Design Review Committee Meeting

June 16, 2021 6:00 PM

**DEPARTMENT OF PLANNING AND ZONING
PLANNER'S REPORT**

DATE: June 11, 2021
TO: Tonya Hutson
FROM: Lynn Patterson
RE: **Design Review – 3571- 3581 South Fulton**

PROPOSED WINDOW CHANGES

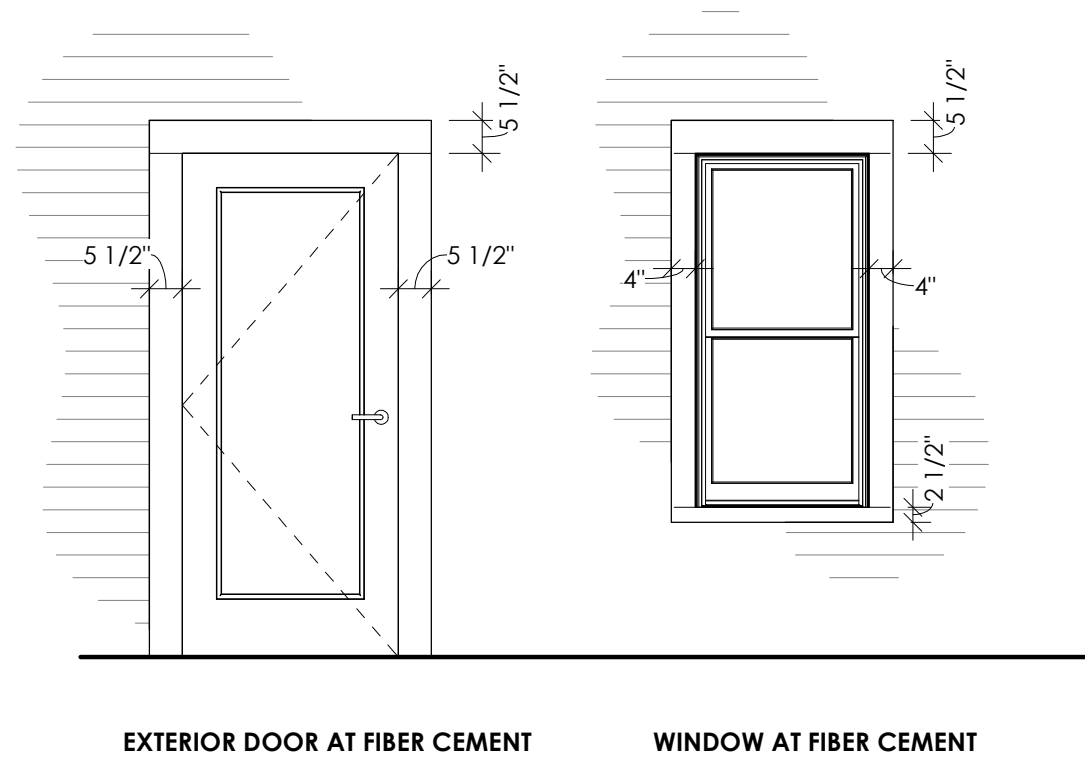
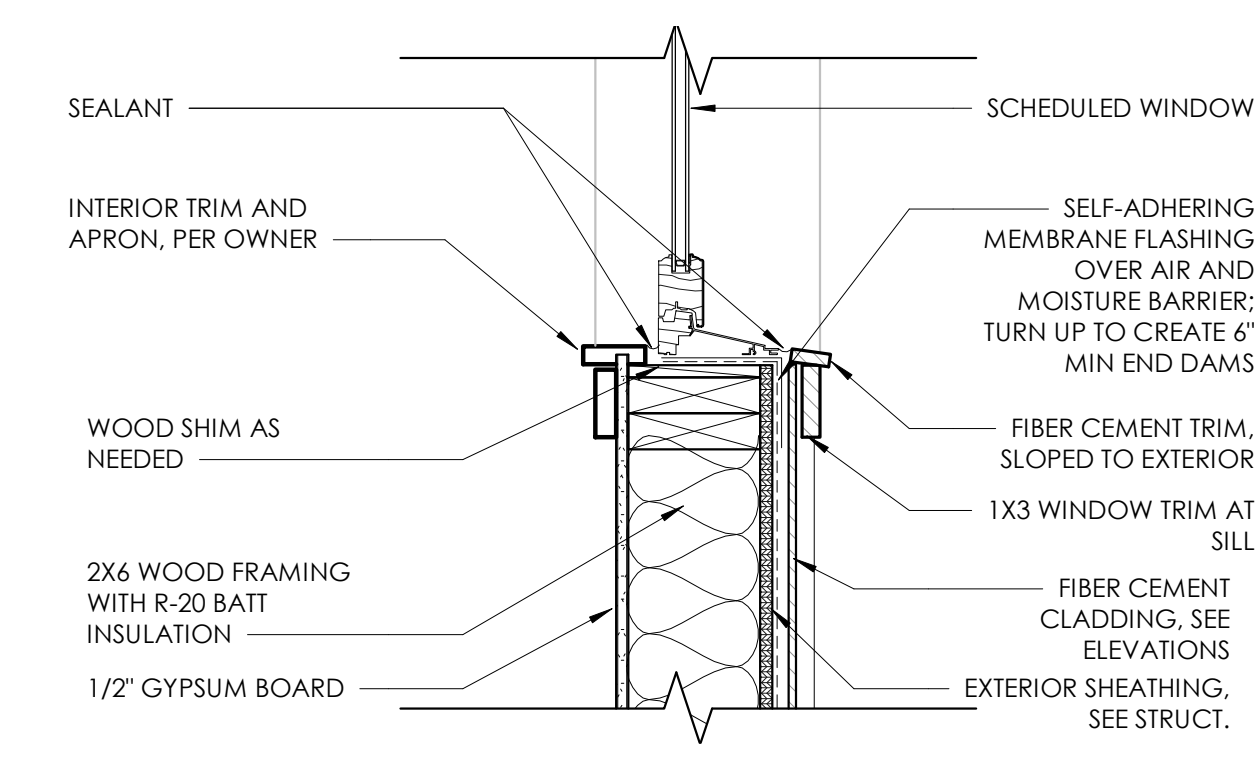
The requested modification is to change one window in each of the townhomes to a 2'0" x 4'0" window. The orientation is still vertical, recesses are met, and other window details are compliant.

The Design Review Committee may approve the modification.

FRONT ELEVATION
SCALE 1/4" = 1' - 0"

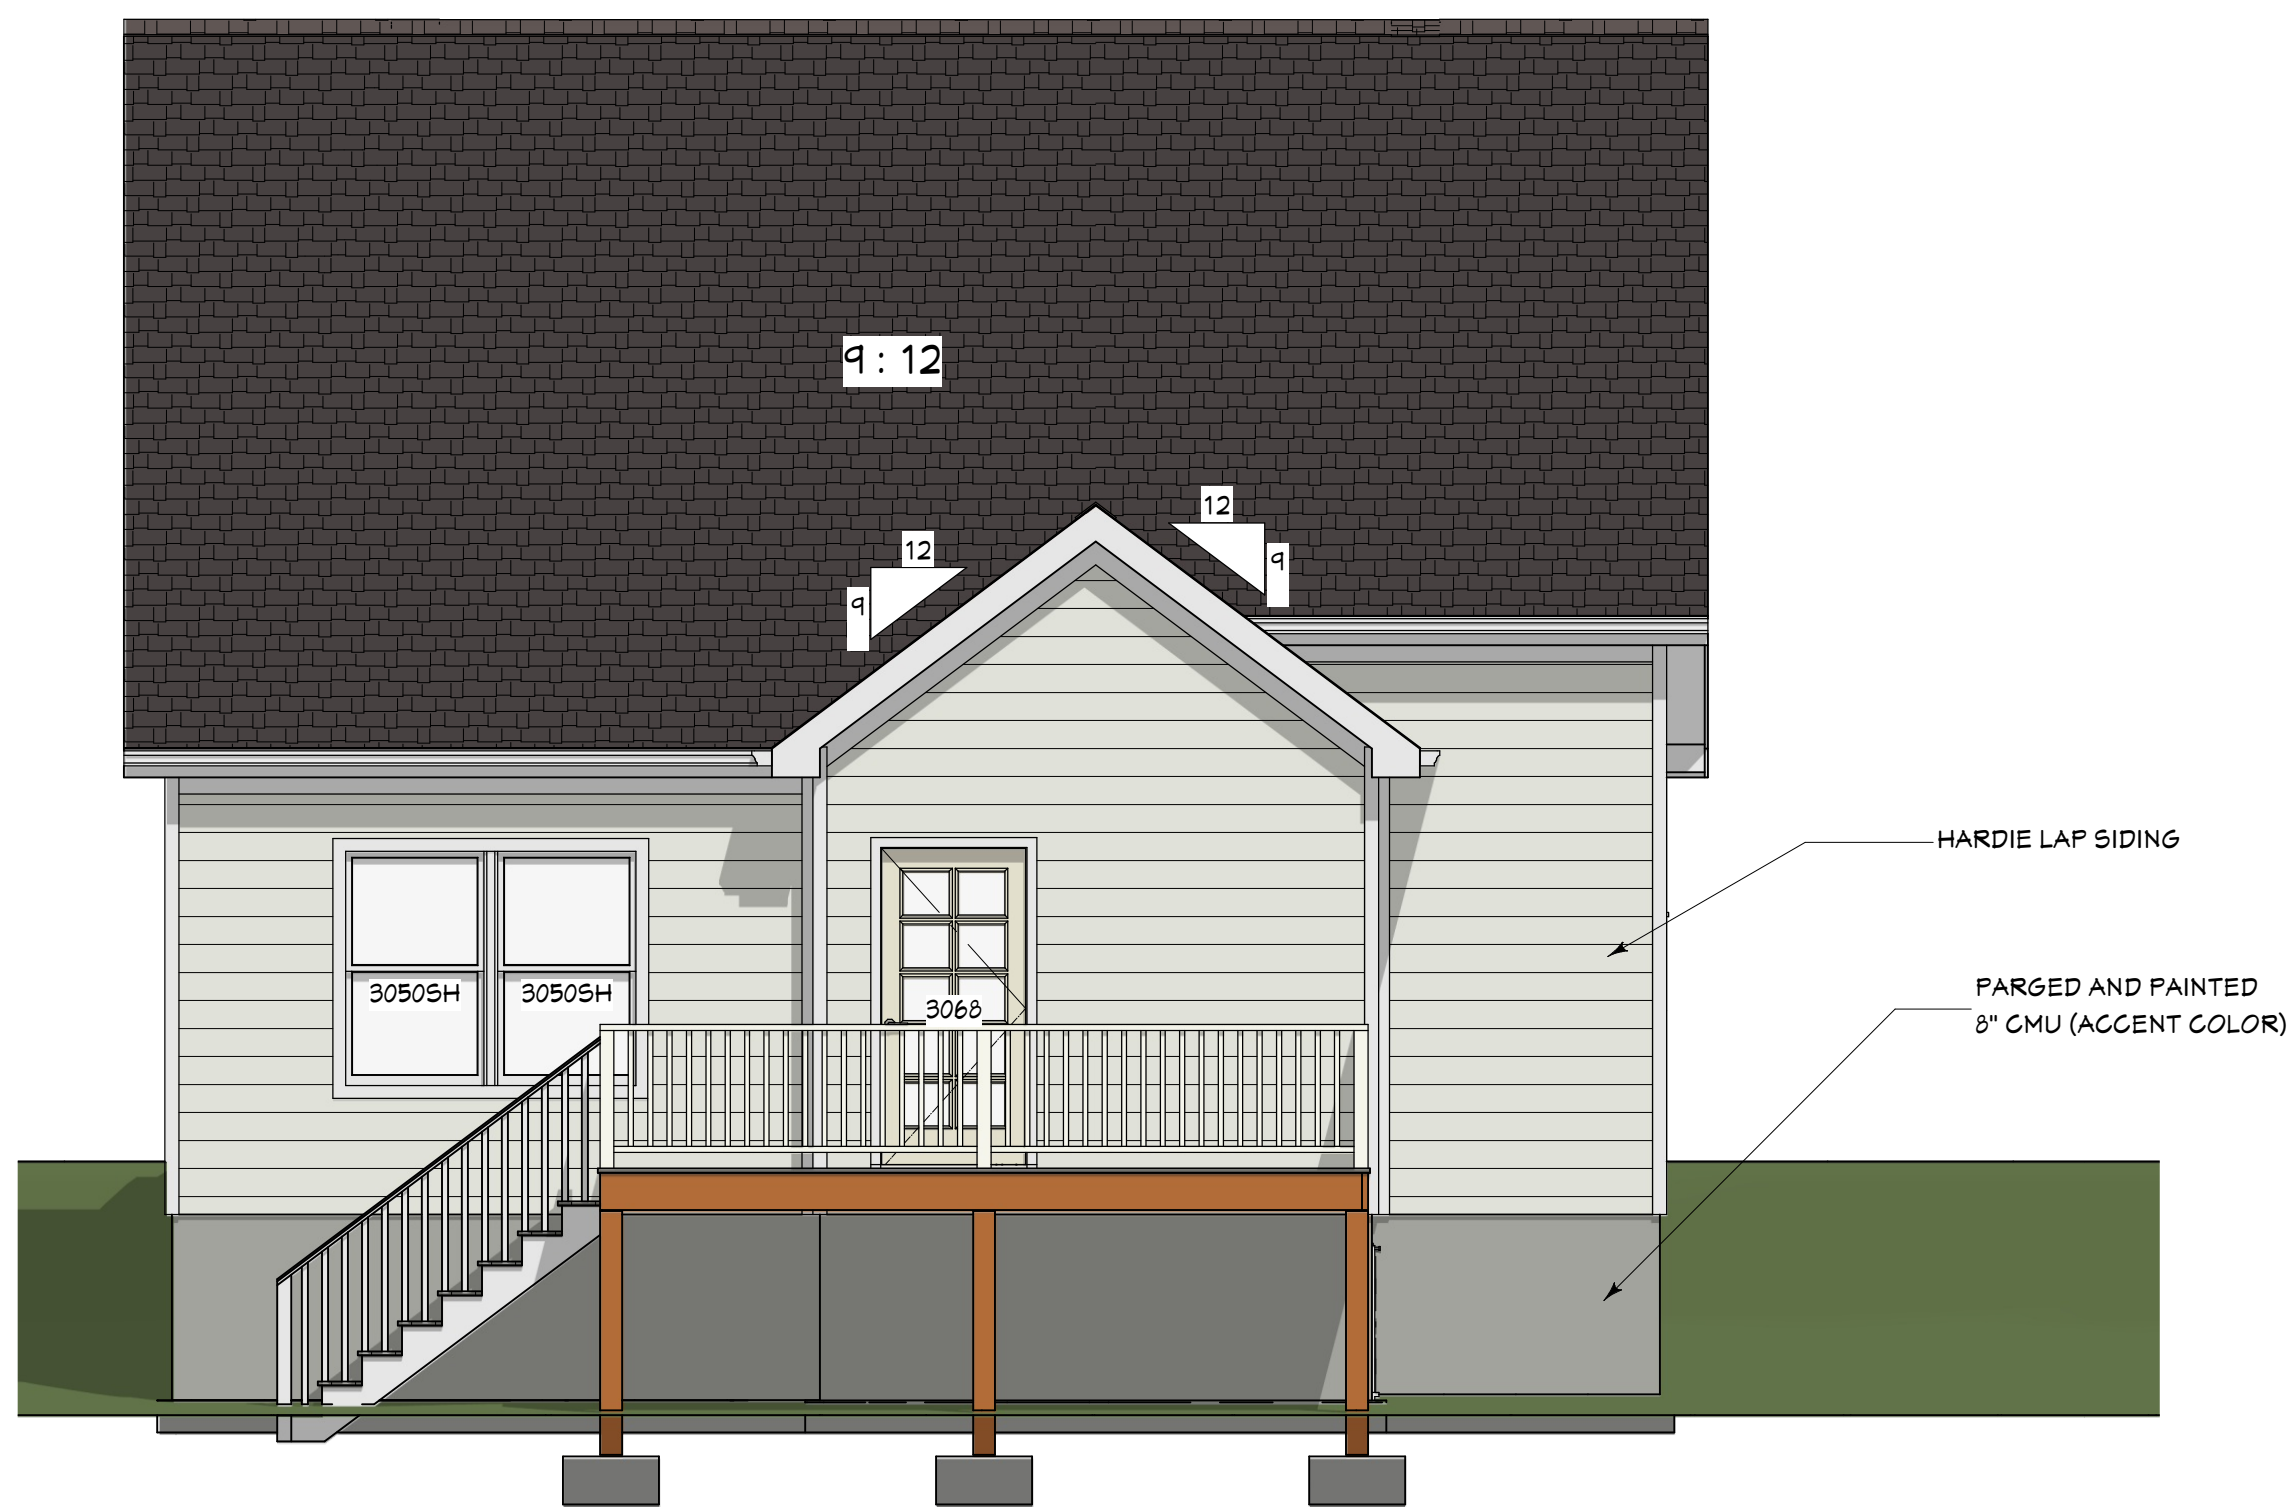
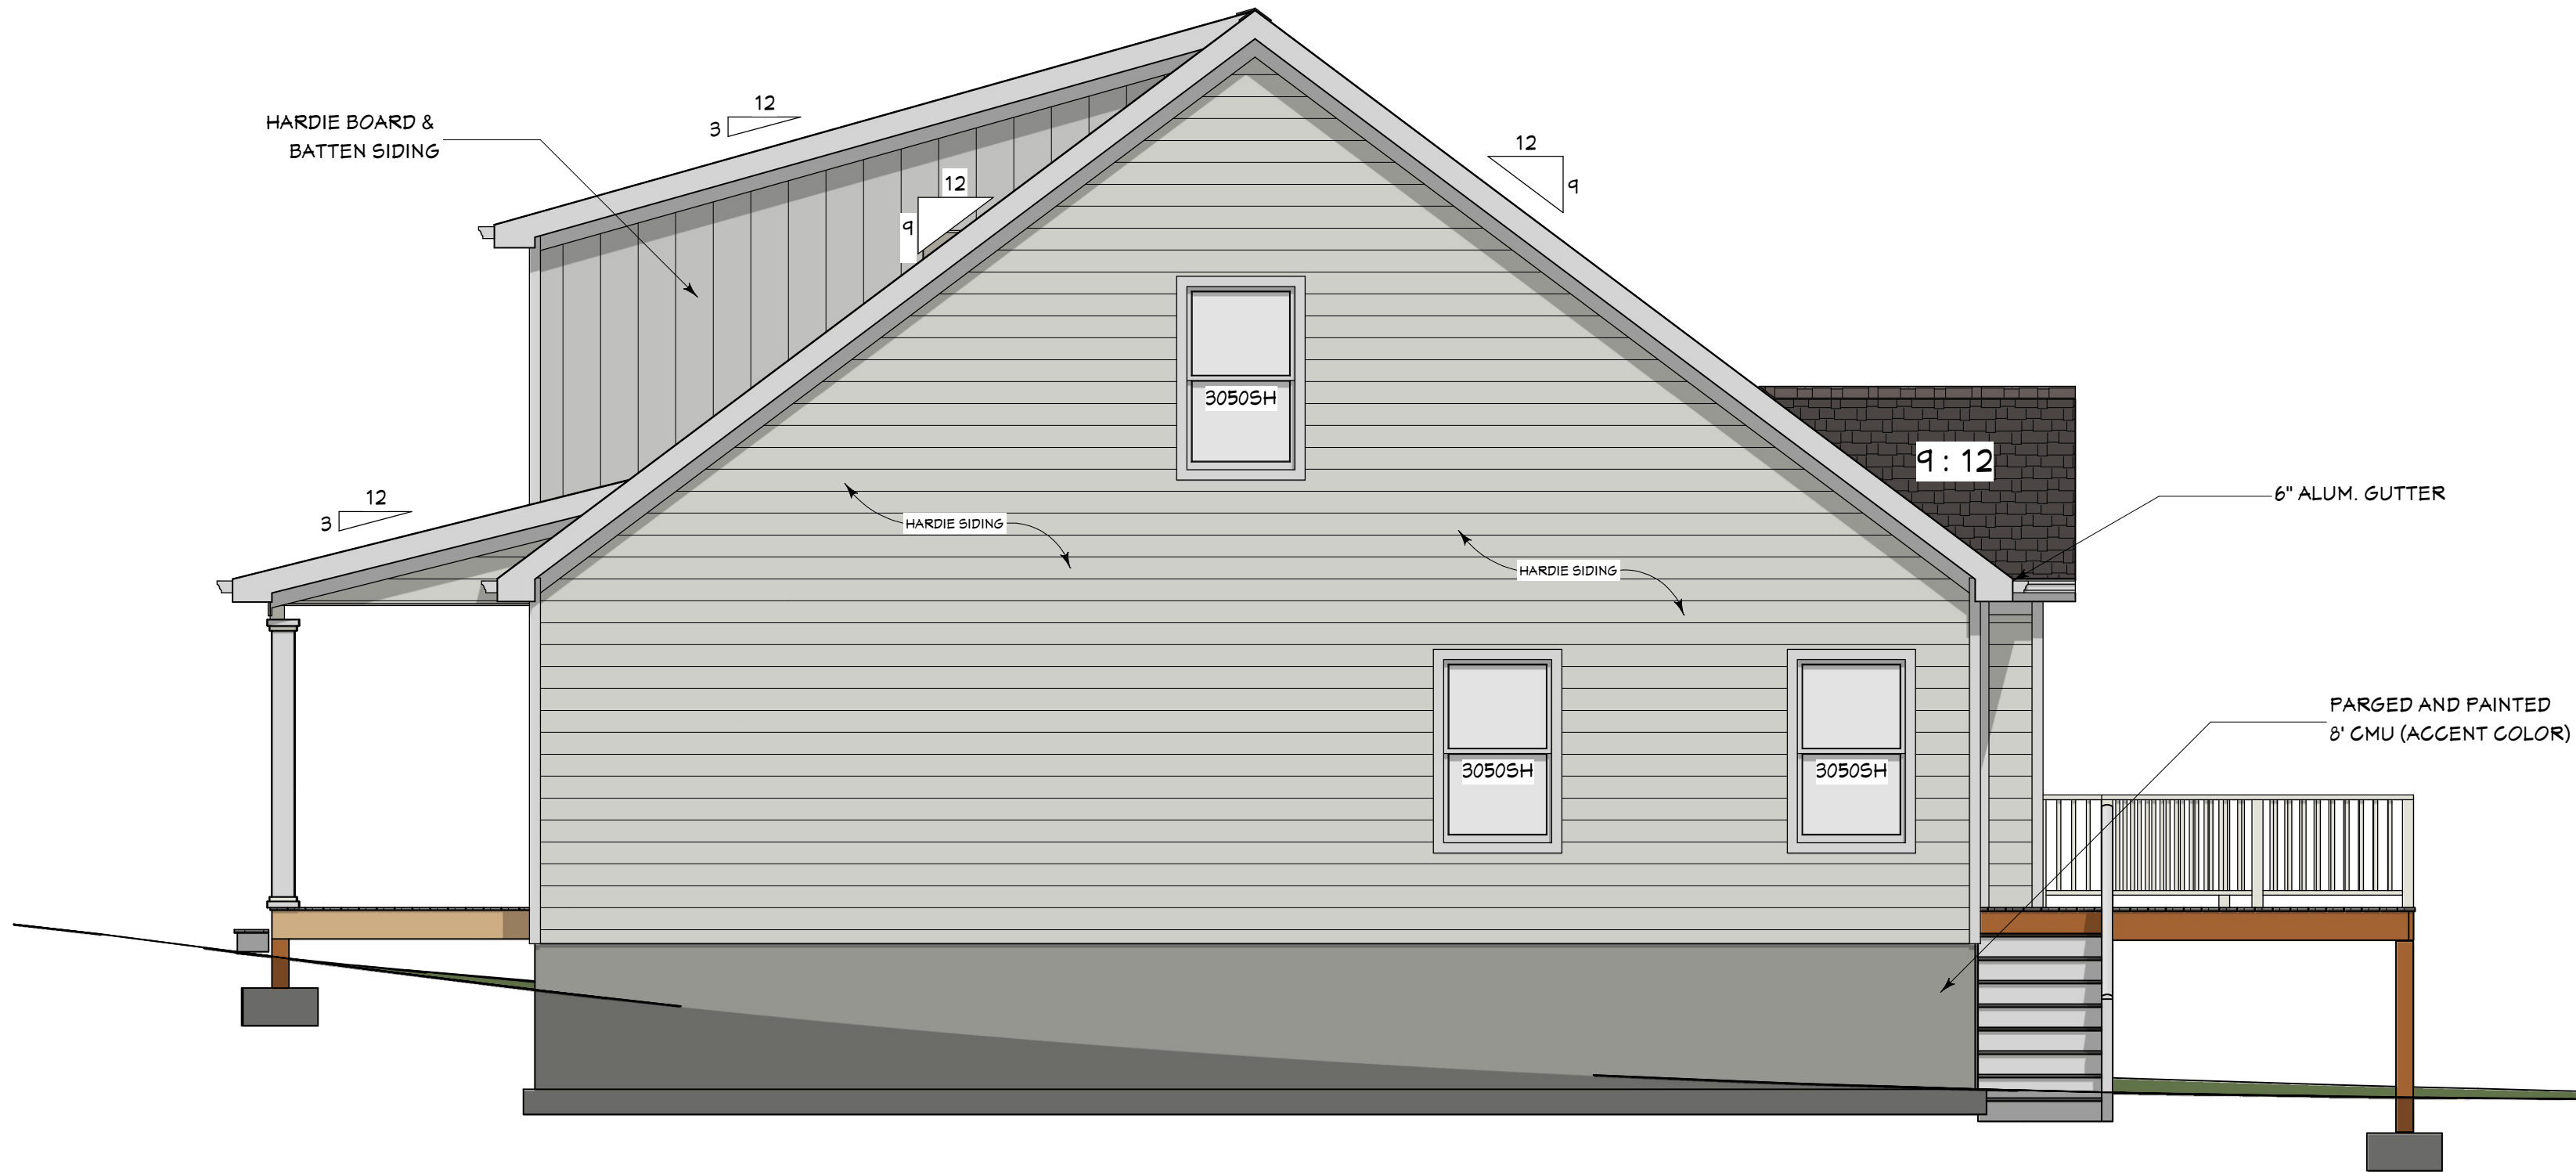
STAFF COMMENT: Ensure mechanical is screened. Ensure front door light is provided.

STAFF COMMENT: Downspouts are not shown.

STAFF COMMENT: All wood must be painted or stained on porches. Foundation should be enclosed. Depth of porch is 7' not 8'.

STAFF COMMENT: Building numbers should be provided. Trim detail should be provided.

STAFF COMMENT: *Provide sill height.*

- Porch should be 8' to meet Standards.
- Downspout locations
- Mechanical screening
- Paint or stain on porches
- Building numbers
- Trim detail to meet standards
- Light at front porch
- Porch foundation enclosure
- Sill height to meet standards
- Approved Tree Conservation Plan (finalize with Arborist)
